Enclosure 1 to IPN - 84-63

SPECIFIC EQUIPMENT DEFICIENCIES LIST

New York Power Authority
Indian Point 3 Nuclear Power Plant
Docket No. 50-286

Figure III-1 LOCA Condition Temperature Vs. Time Profile Within Containment

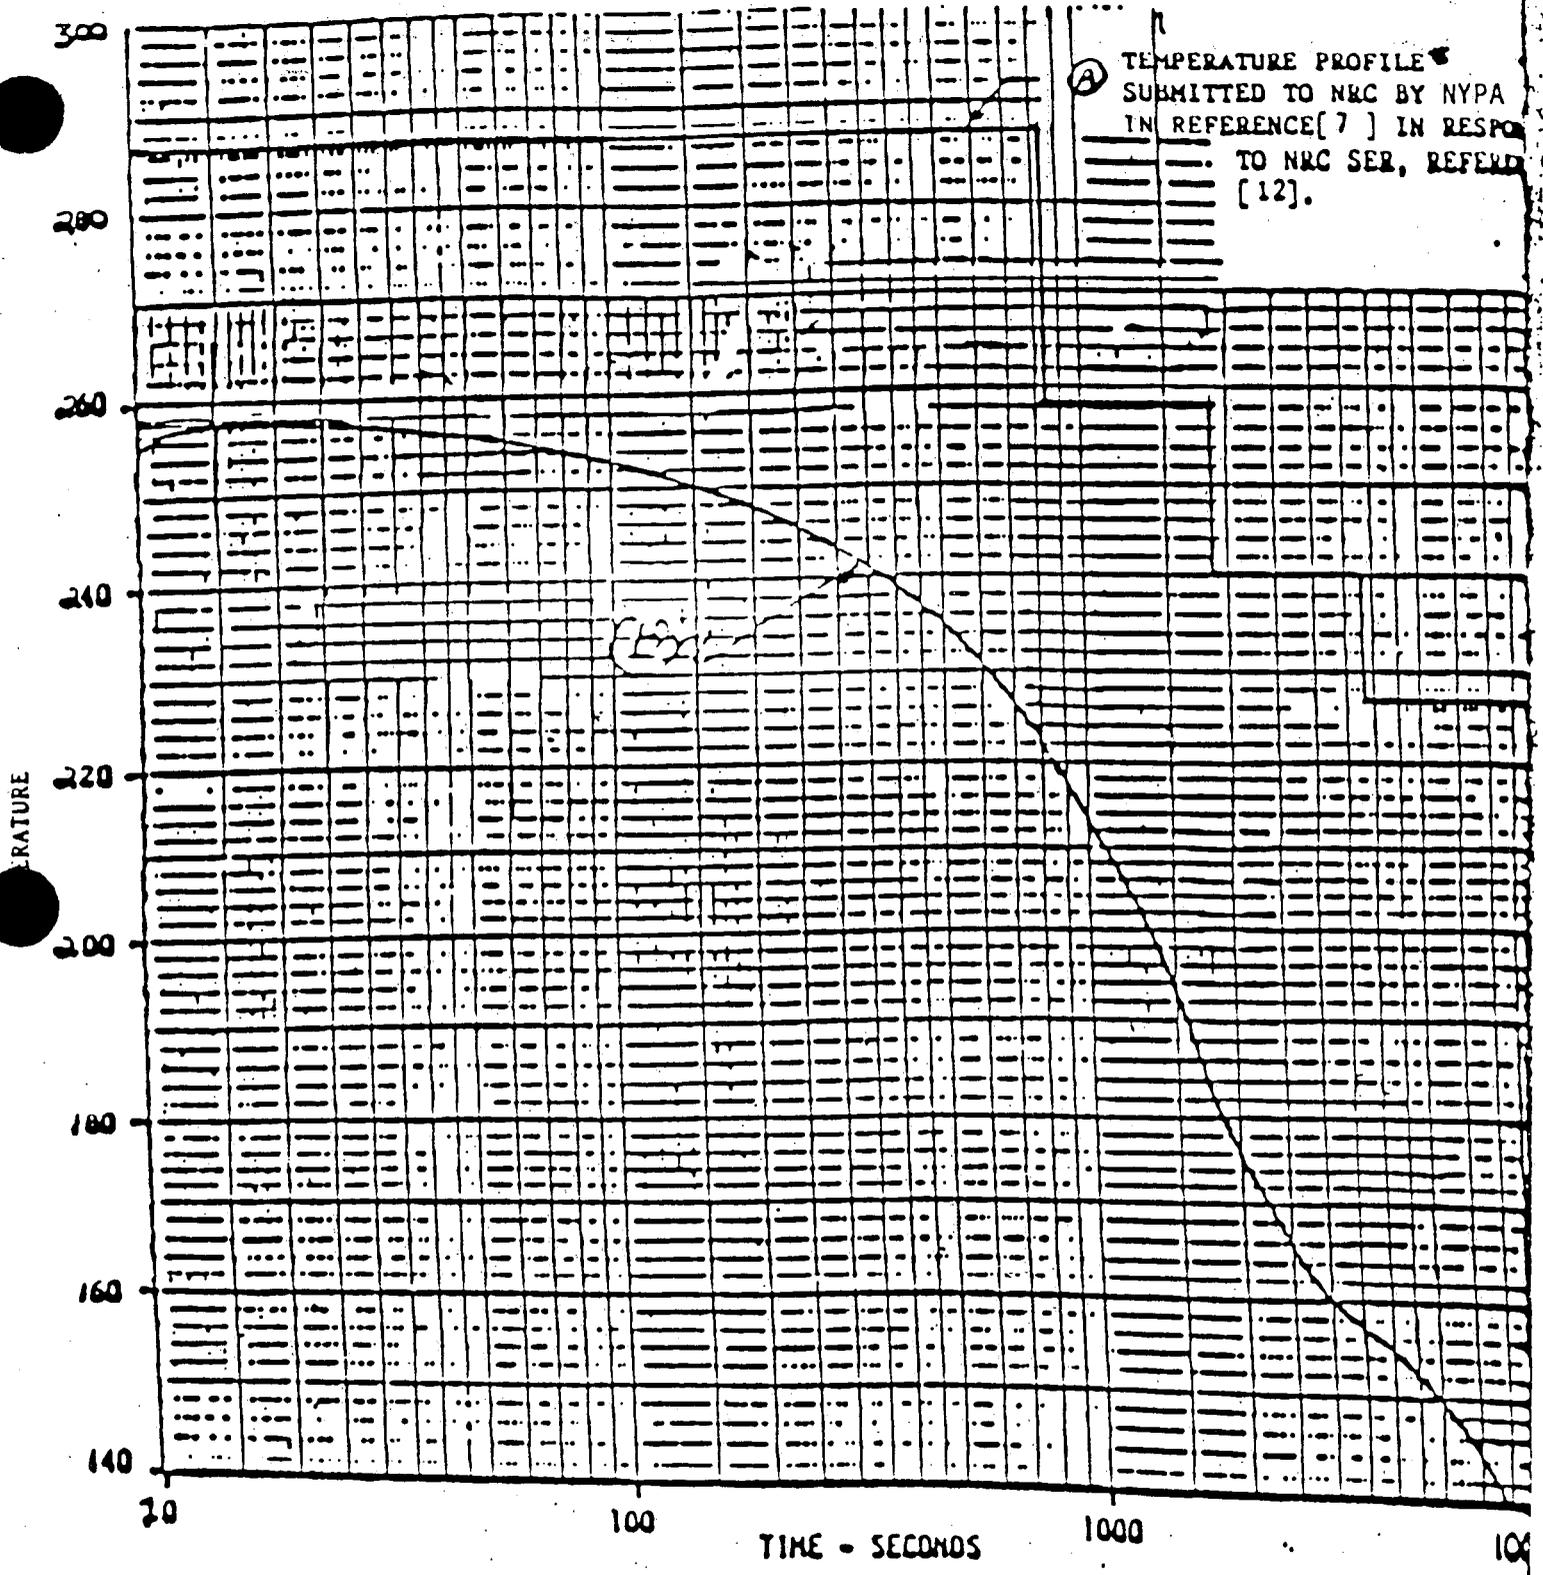
"The staff has concluded that the minimum temperature profile for equipment qualification purposes should include a margin to account for higher than average temperatures in the upper regions of the containment that can exist due to stratification especially following a postulated MSLB. Use of the steam saturation temperature corresponding to the total building pressure (partial pressure of steam plus partial pressure of air) versus time will provide an acceptable margin for either a postulated LOCA, or MSLB, whichever is controlling as to potential adverse environment effects on equipment.

The licensee's specified temperature (service condition) of 258^oF (the NYPA submittal actually used 271^oF) does not satisfy the above requirements. Furthermore the Licensee's specified pressure is low as compared to the plants of similar design. The Licensee is requested to verify that the pressure profile in the FSAR was calculated based on the code requirements defined in the NUREG-0588. If by using these codes the peak containment pressure is still 40 psig, then a saturation temperature corresponding to the pressure profile should be used."

"The correct peak pressure is 40.6 psig. The temperature reported is the saturation temperature at the steam partial pressure of 36.9 psig. According to the SER the peak temperature reported should be the saturation temperature corresponding to the total containment pressure to account for margin. The saturation temperature at 55.3 psia (40.6 psig) is 287^oF.

The curve for saturation temperature corresponding to the pressure profile is shown in Figure III-1 A.
